MILWAUKIE PLANNING COMMISSION
Tuesday, September 12, 2017, 6:30 PM

- 5.2 Summary: Project Galaxy Design Review *Continued from 8/22/2017*
Applicant/Owner: Kurt Schultz, SERA Architects
Address: 2036 SE Washington St
File: DR-2017-001, VR-2017-007
Staff: Denny Egner for Vera Kolias

To: Planning Commission
Through: Dennis Egner, Planning Director
From: Vera Koliass, Associate Planner
Date: September 5, 2017 for September 12, 2017 Public Hearing
Subject: File(s): DR-2017-001; VR-2017-007
Applicant: Kurt Schultz, SERA Architects
Address: 2036 SE Washington St
Legal Description (Map & Taxlot): 11E36BC01600
NDA: Historic Milwaukie

Figure 1. MMC 19.304.5.B.2

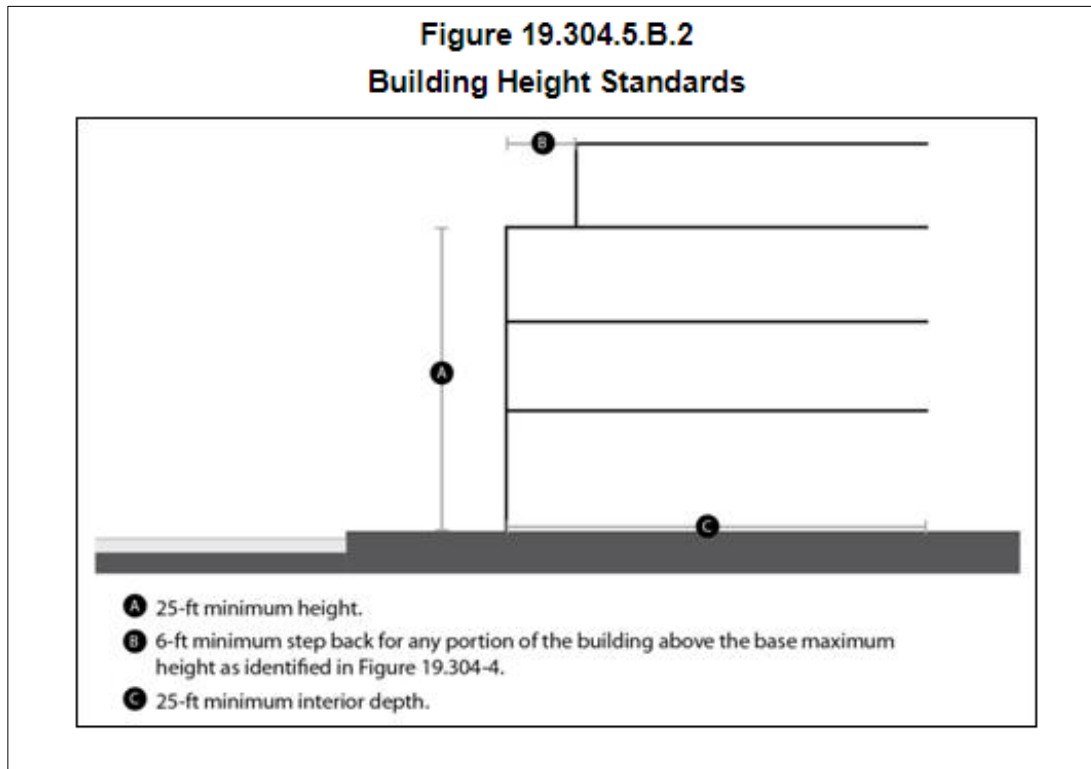
Per MMC 19.304.5, buildings shall provide a step back of at least 6 ft for any street-facing portion of the building above the base maximum height (see Figure 1). The intent of this standard is to promote a compatible building scale. This development standard is also part of the Building Façade Details design standard in MMC 19.508.4.A. The purpose of this

standard is to provide cohesive and visually interesting building façades in the downtown. The middle of a building extends from the top of the building base to the ceiling of the highest building story and is distinguished from the top and base of the building by use of building elements, such as a 6-ft minimum building step-back on the 3rd floor or higher, for at least 25% of the length of the building.

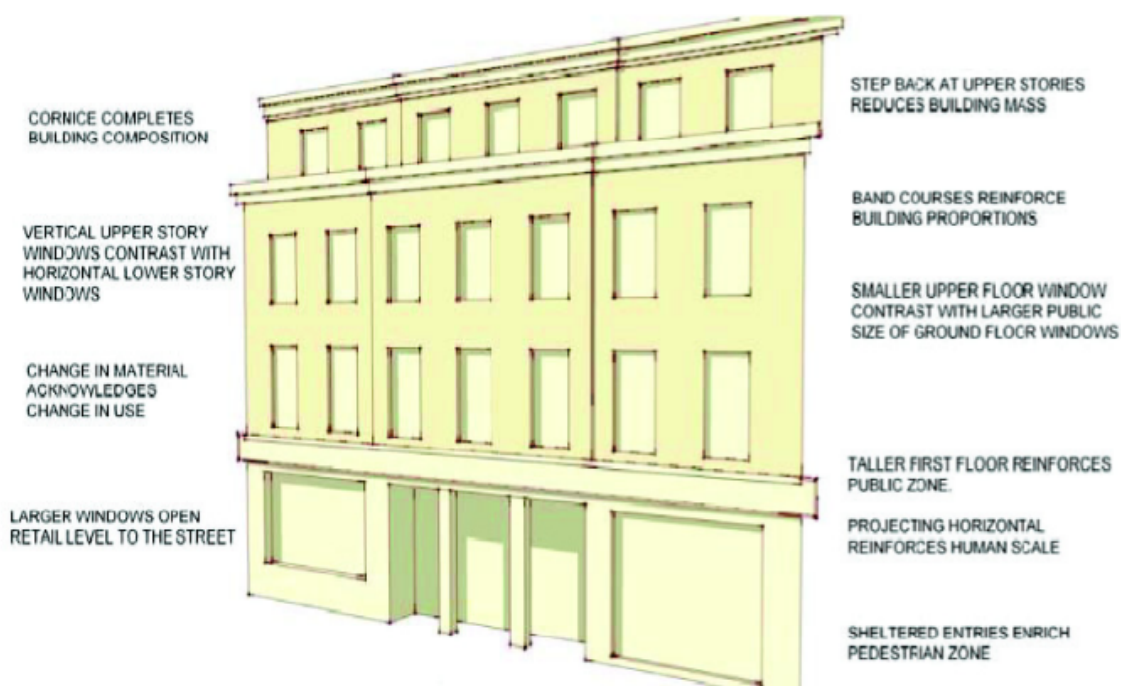
I remain very concerned about the design proposals by the applicant for 2036 SE Washington. I spent a great deal of time as a Planning Commissioner and as a City Councilor to make sure of proper "bulk and mass" and "pedestrian scaled experience" in regards to building development.....especially in the downtown zone.

This application...and it's recent new shadow box additions along Washington street.....unfortunately.....still fall short of the intent of the code. These additional shadow box features actually INCREASE the Bulk and Mass of the building.....from the pedestrian experience along the south side of Washington street.

The base building height in this zone is 3 floors. Floors 4 and 5when allowed.....are BONUS FLOORSand as such require by code to have a 6'-0" setback. They are NOT a project entitlement. This setback is critical to the proper "bulk and mass" and "pedestrian scaled experience" in regards to building development. These upper floors are not required.....they are a BONUS which requires a set back to reduce BULK AND MASS.
